## HORSHAM DISTRICT COUNCIL CONSULTATION

| <b>LOCATION:</b>                                                                                                                                                                                                                                                                                                                                                                                                                                                                                                                                                                                                                                                                                                                                                                                                                                | Land Parcel at 519887 133300 Rusper Road Horsham West Sussex                                                                                                                                                                                                                                                                                     |

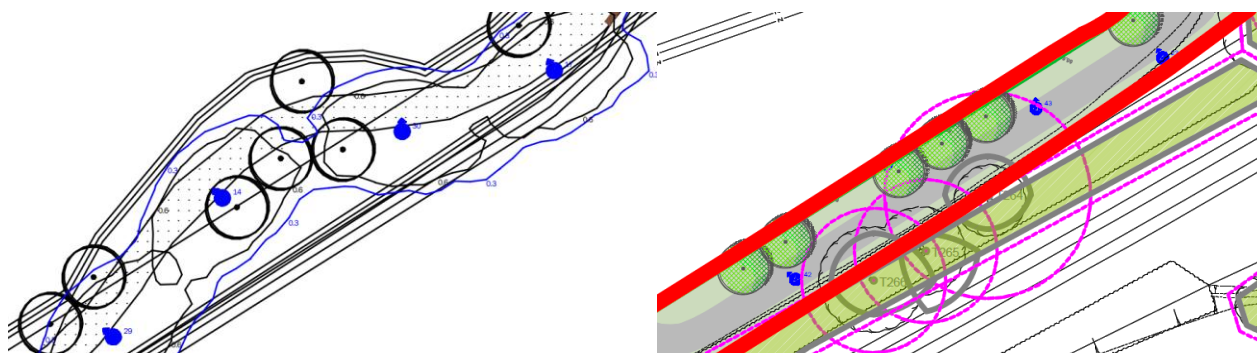
5. As such, while the following examples adhere to minimum recommendations, the default position should be that development occurs outside of RPAs. We therefore request that footpaths and cycle paths are altered to avoid these areas. Please see examples below.

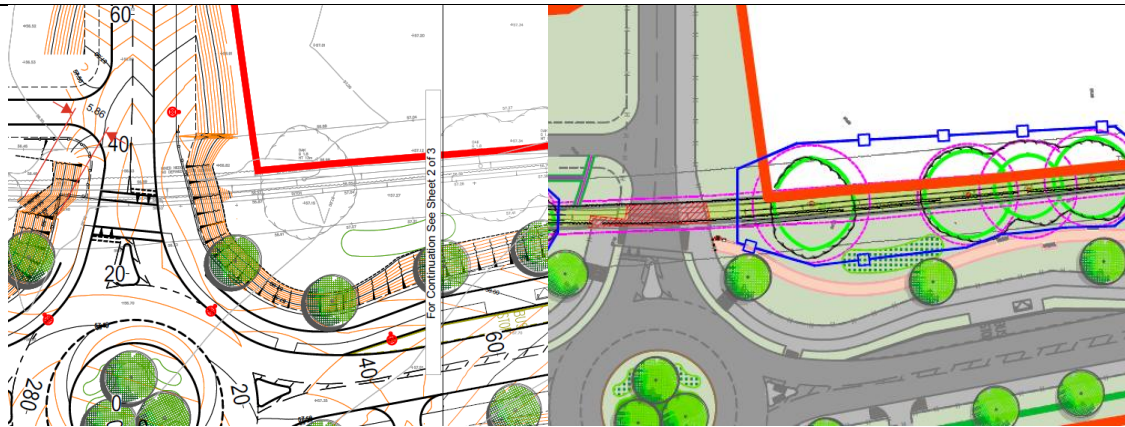
6. As above, in the example below, the original layout as reflected in the lighting plans is preferred. In any case, we note that 'low-dig' has not been indicated within the Tree Protection Plan (TPP) and must be amended accordingly.

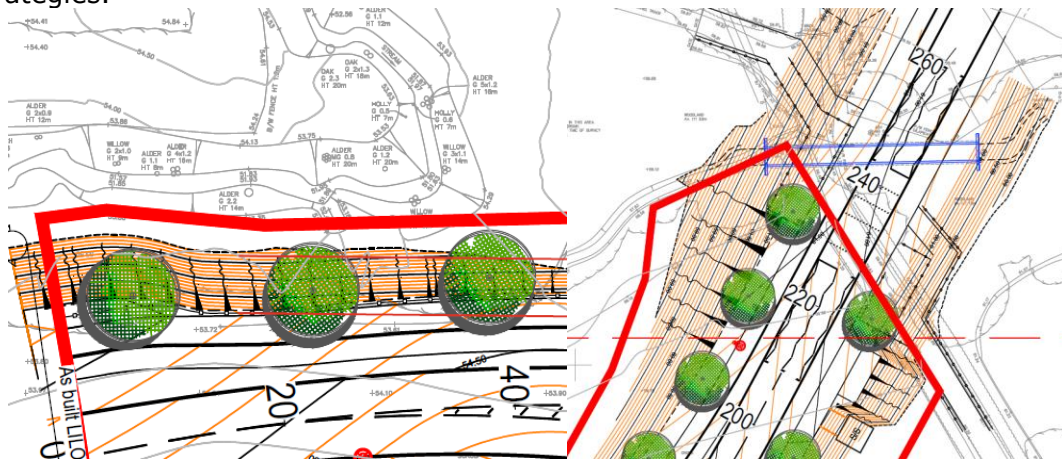
10. For example, while the road layout below is subject to a separate reserved matters application, major concern is raised in regard to the significant earthworks proposed within priority habitat woodland, which is reflected as retained within the TPP. As per points 2 and 4, this landscape feature must be avoided and thus we recommend reducing or removing changes to the topography.

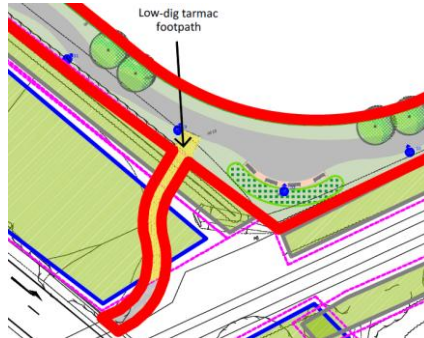
18. We note within the AIA under section 5.18 that footpaths within RPAs will be porous to better allow tree roots to thrive. As such, we request the low-dig section below to reflect a porous material.

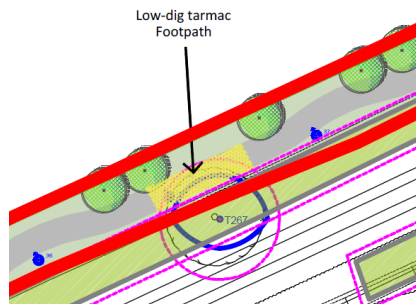
19. As above, the section below should reflect a porous material. However, as per point 5, the default position is that it should avoid the RPA entirely.

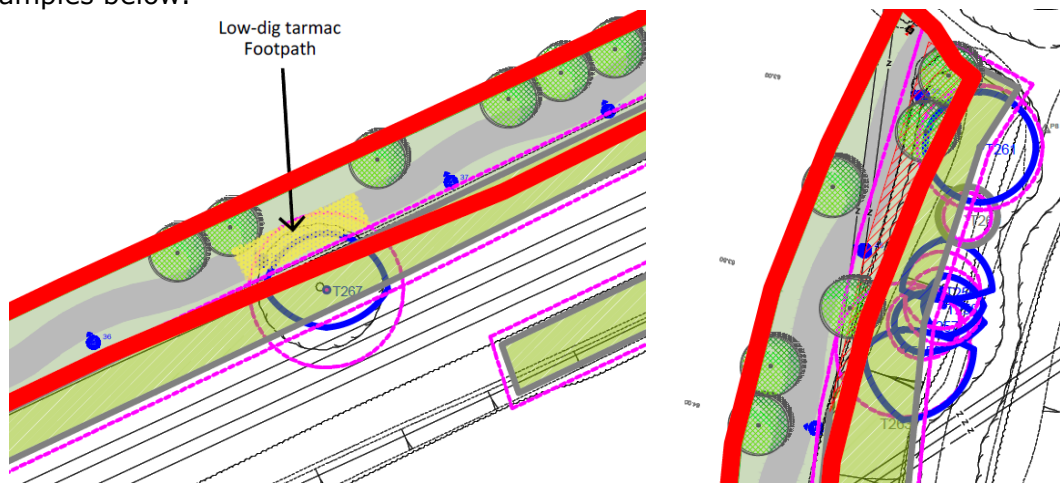
28. Kirium 200 Bollards are indicated within the lighting layout plan, however Kirium 160 Bollards are indicated in the lighting document. Regardless, the lighting layout has considered 1725 lumens, which reflects neither product. Please confirm that Kirium 160 Bollards are the proposed, specifying the 2700K model so as to minimise adverse effects on surrounding existing vegetation.
29. Uplighters and columns are also indicated in the lighting document, but no locations or associated lux levels are indicated in plan. Please amend accordingly.
30. Please confirm if no lighting is proposed for the footpaths and cycle paths north of the main road.
31. As per points 2 and 4, we recommend that utilities avoid RPAs where possible. As such, please consider slightly altering the locations of bollards and associated utility runs – see examples below.
